# LV Battery & BMS

### Designing a low voltage (lv) battery pack for MKV's LV electronics system, including Pack configuration and BMS PCB.

**DR2** - notes from electrical Leads Design Review 2

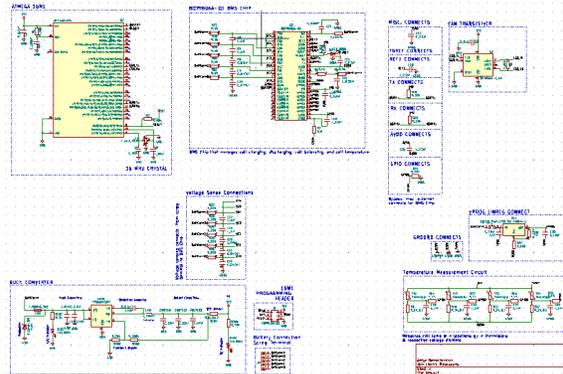
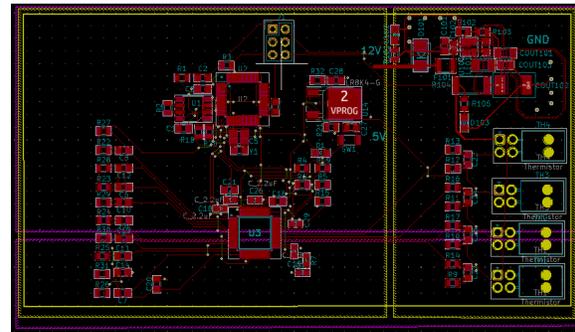
**Big Picture** - They roasted the PCB Schematic but confirmed we were on track

- Programming LED's
- UARTS
- Internal Regulation? Does this chip have it?
- External Relays and how this board interacts with them
- Naming conventions - need to fix
- Battery + , Battery - need two separate connections?
- Different Grounds - DVDD, AVSS, etc.
- NFAULT pin - need an LED
- LDOIN pin - Consider the battery / capacitor connection
- Thermistor Connectors - micromatch?
- How we will trigger WAKEUP pin?
- Do UART connections need pull up resistors?
